## AGENDA Lexington Planning Board

### Thursday, June 21, 2018 Hudson Room, Cary Memorial Building, 1605 Mass Avenue 7:00 PM

#### Re: 443 Lincoln St., Lexington, MA

Re: Homes at Hobbs Brook 443 Lincoln Street

Figure 1

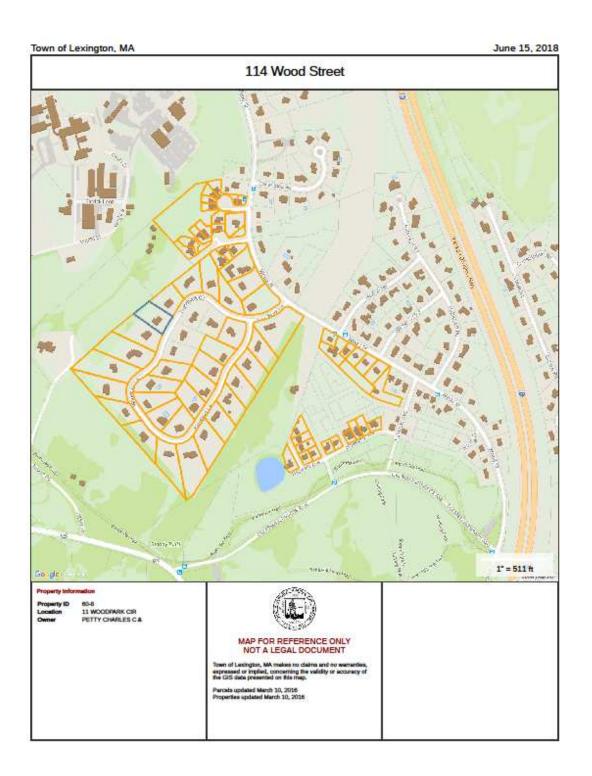
Staff suggests that the applicant contact NStar, or other utility provider responsible for the easement across the property in question, to determine the likelihood that the utility would allow development activity on the land within the easement, particularly if any utilities for the proposed development are to run under powerlines. There is also a sewer easement on the property that, if this plan proceeds to the definitive stage, would need to be reviewed by the engineering office to gauge their comfort level on crossing this easement with a paved way and/or other utilities.

Additionally, the applicant should review the common driveway with the fire department as the plan calls for 10 foot wide, two way access to the two additional homes proposed. The planning office would need confirmation from the fire department that this is acceptable for the maneuverability of their vehicles and that the hammerhead configuration in front of the two proposed homes is an acceptable turnaround for their vehicles.
